# CITY OF ALBUQUERQUE

November 8, 2022

Re: 2444 Louisiana 2444 Louisiana Blvd. NE Traffic Circulation Layout Engineer's/Architect's Stamp XX-XX-XX (H19-D093)

Based upon the information provided in your submittal received 11-01-22, the above referenced plan cannot be approved for Building Permit until the following comments are addressed:

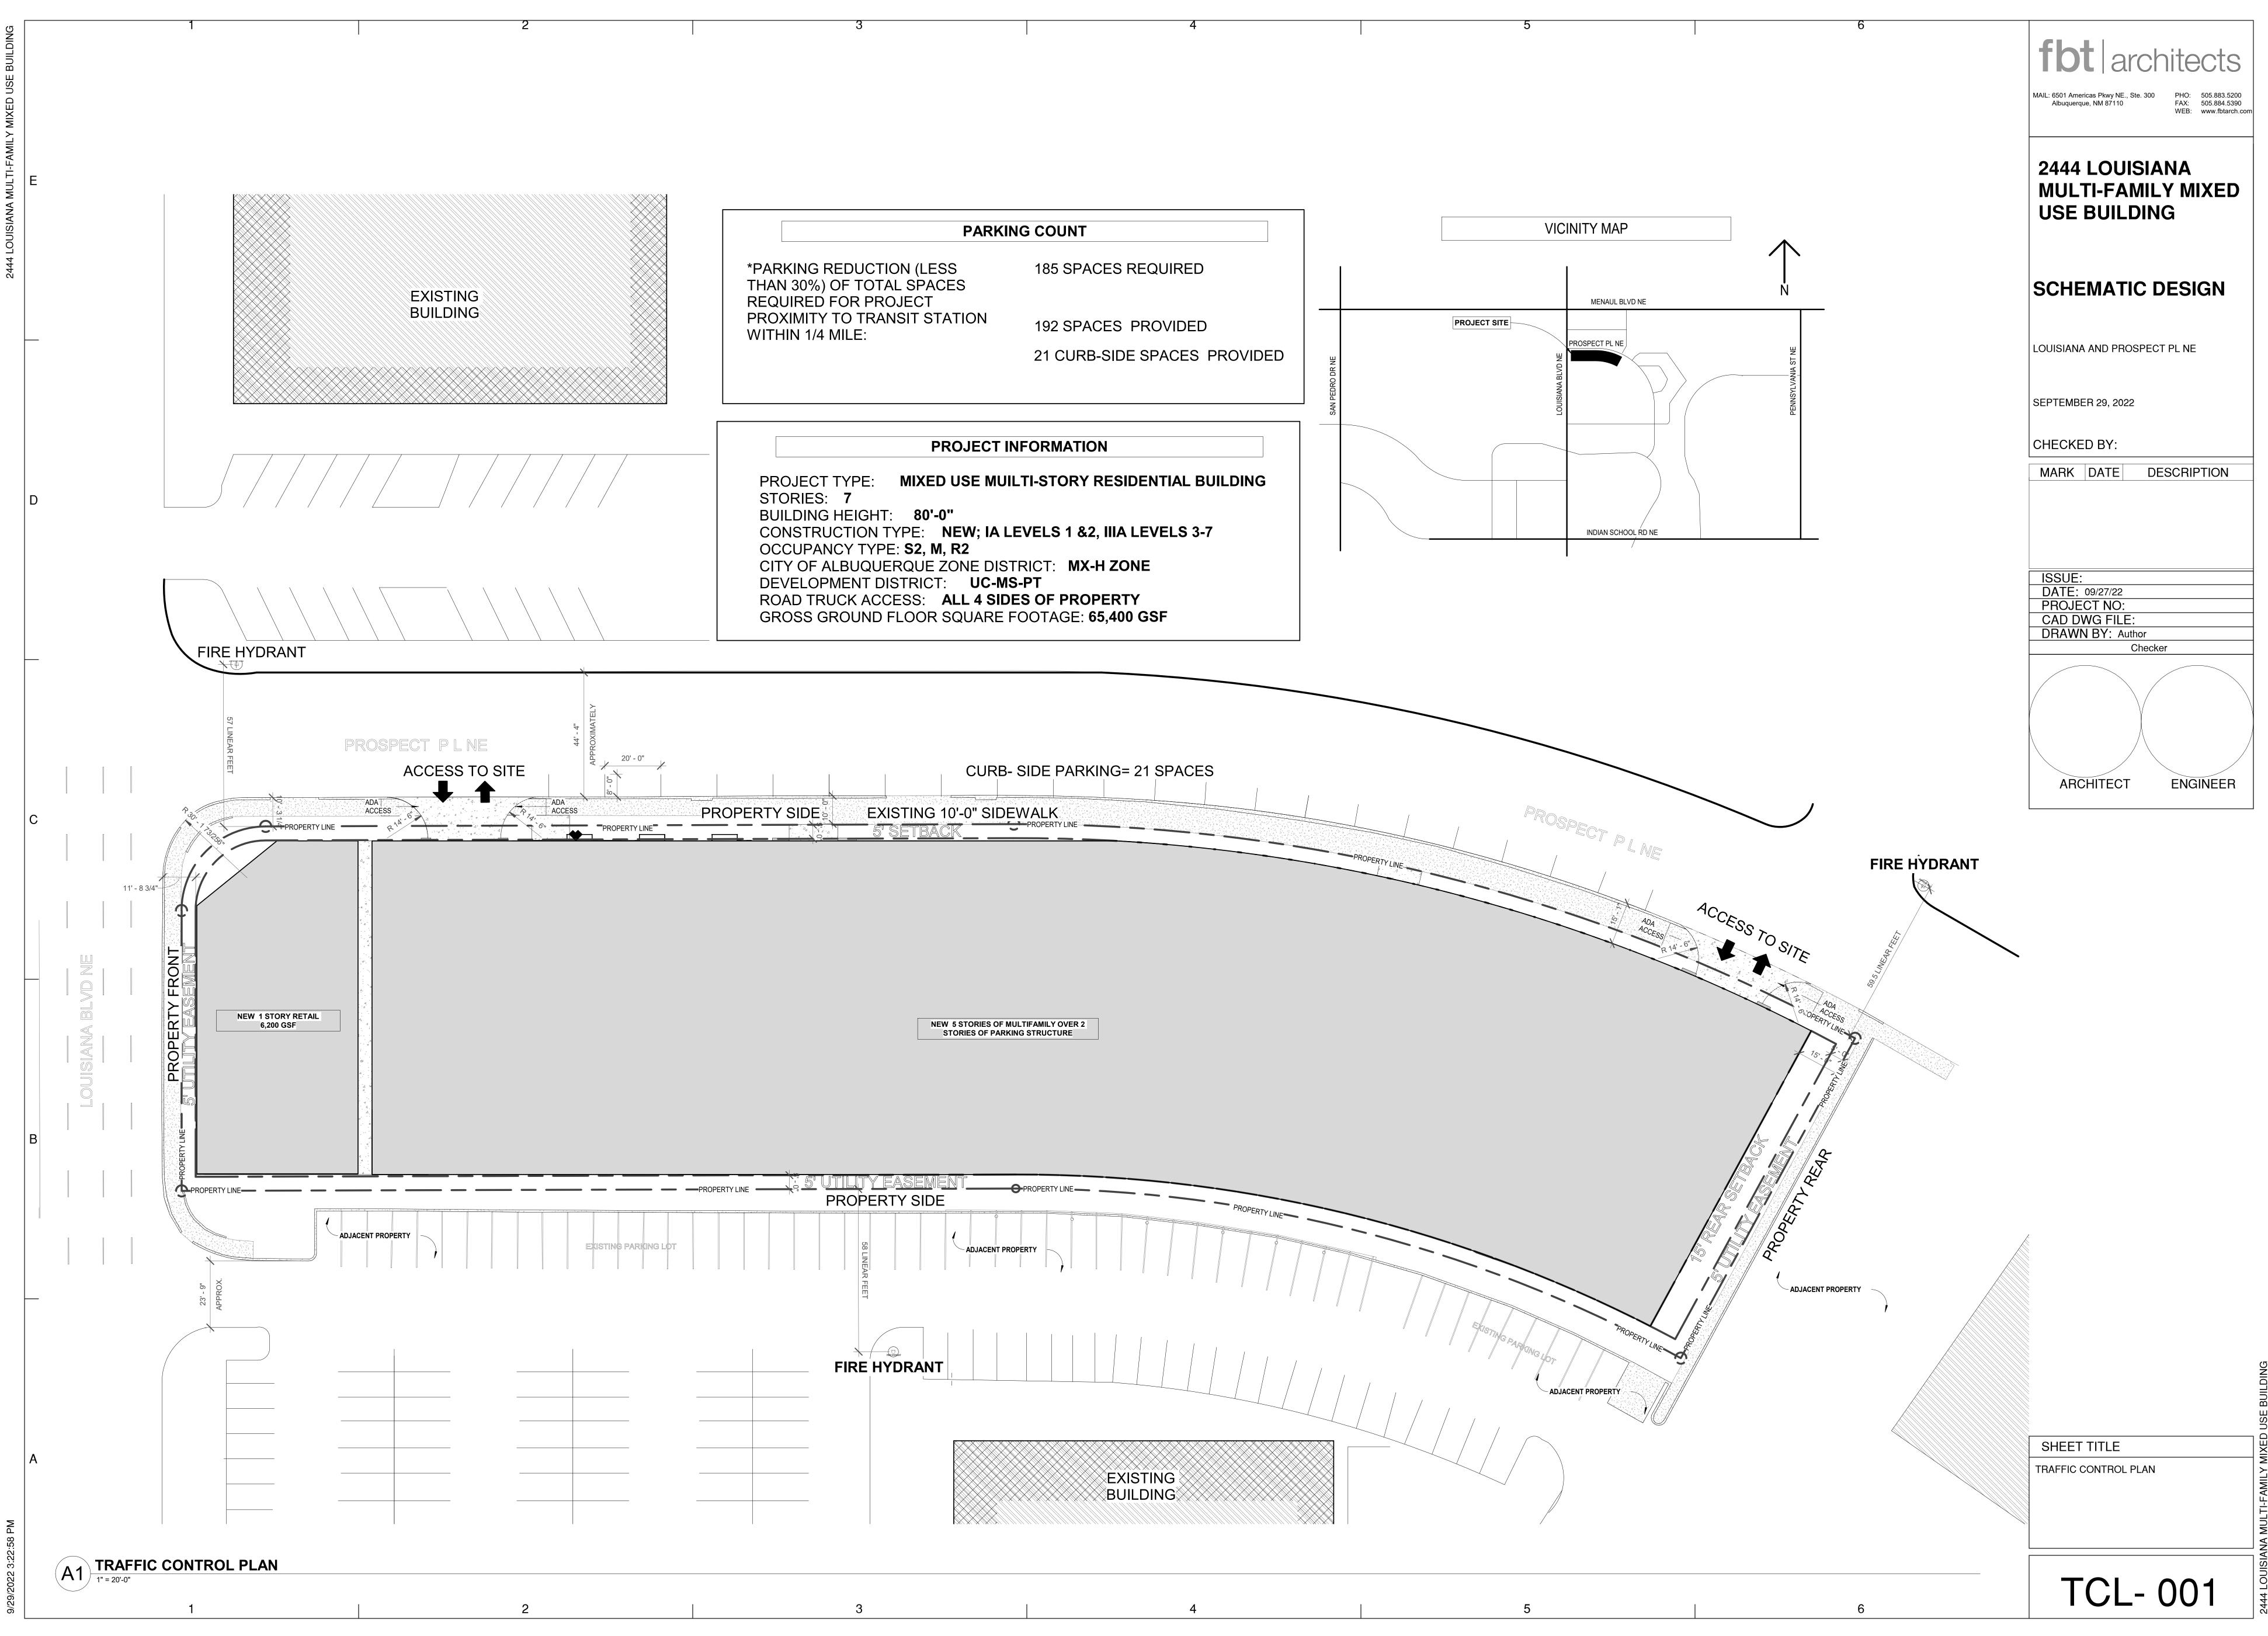
1. List the number of Motorcycle parking and Bicycle parking spaces required by the IDO

- 3. Per the DPM Table 7.4.45, Site access off Prospect PI NE, must be 75 ft. away from the intersection. See attached. Please show this distance on the site plan.
- 4. Please provide design details for the site driveways accesses off Prospect PI. and call out COA std dwg.
- NM 87103 5. Please list the width and length for all existing and proposed parking spaces. Some dimensions are not shown.
  - 6. The minimum parking stall dimensions are:

- 7. Label the compact parking spaces by placing the words "**COMPACT**" on the pavement of each space.
- 8. The ADA accessible spaces must include an access aisle. Van accessible aisles should be 8ft wide; all others should be 5ft wide.
- 9. The ADA accessible parking sign must have the required language per 66-7-352.4C NMSA 1978 "Violators Are Subject to a Fine and/or Towing." Please call out detail and location of signs.

10. The ADA access aisles shall have the words "NO PARKING" in capital letters, each of which shall be at least one foot high and at least two inches wide, placed at the rear of the parking space so as to be close to where an adjacent vehicle's rear tire would be placed. (66-1-4.1.B NMSA 1978) ADA curb ramps must be updated to current standards and have truncated domes 11. installed. 12. Motorcycle parking spaces shall be designated by its own conspicuously posted upright sign, either free-standing or wall mounted per the zoning code. 13. The pavement marking "MC" should be shown in the opposite direction for motorcycles entering the parking space. 14. All bicycle racks shall be designed according to the following guidelines: a. The rack shall be a minimum 30 inches tall and 18 inches wide. b. The bicycle frame shall be supported horizontally at two or more places. Comb/toaster racks are not allowed. c. The rack shall be designed to support the bicycle in an upright position. See the IDO for additional information. d. The rack allows varying bicycle frame sizes and styles to be attached. e. The user is not required to lift the bicycle onto the bicycle rack. Each bicycle parking space is accessible without moving another bicycle. f. 15. Bicycle racks shall be sturdy and anchored to a concrete pad. 16. A 1-foot clear zone around the bicycle parking stall shall be provided. Bicycle parking spaces shall be at least 6 feet long and 2 feet wide. 17. Show all drive aisle widths and radii. Some dimensions are not shown. 18. The minimum drive aisle dimensions are shown below 19.

- 20. Per the IDO, a 6 ft. wide ADA accessible pedestrian pathway is required from the public sidewalk to the building entrances. Please clearly show this pathway and provide details.
- 21. Per DPM, a 6 ft. wide ADA accessible pedestrian pathway is required from the ADA parking stall access aisles to the building entrances. Please clearly show this pathway and provide details.

- 22. ADA accessible pedestrian pathway should not be placed behind parking space or adjacent to a vehicular way. Vehicle and pedestrian/wheel chair conflicts should be avoided as much as possible.

- 23. Please provide a copy of Fire Marshal and Solid Waste approval.
- 24. All one-way drives shall have "One Way" and "Do Not Enter" signage and pavement markings. Please show detail and location of posted signs and striping.

- 25. Please provide a sight distance exhibit
- 26. Show the clear sight triangle and add the following note to the plan: "Landscaping and signage will not interfere with clear sight requirements. Therefore, signs, walls, trees, and shrubbery between 3 and 8 feet tall (as measured from the gutter pan) will not be acceptable in the clear sight triangle.

- 27. Please specify the City Standard Drawing Number when applicable.
- 28. Add a note stating "All broken or cracked sidewalk must be replaced with sidewalk and curb & gutter." A build note must be provided referring to the appropriate City Standard drawing.
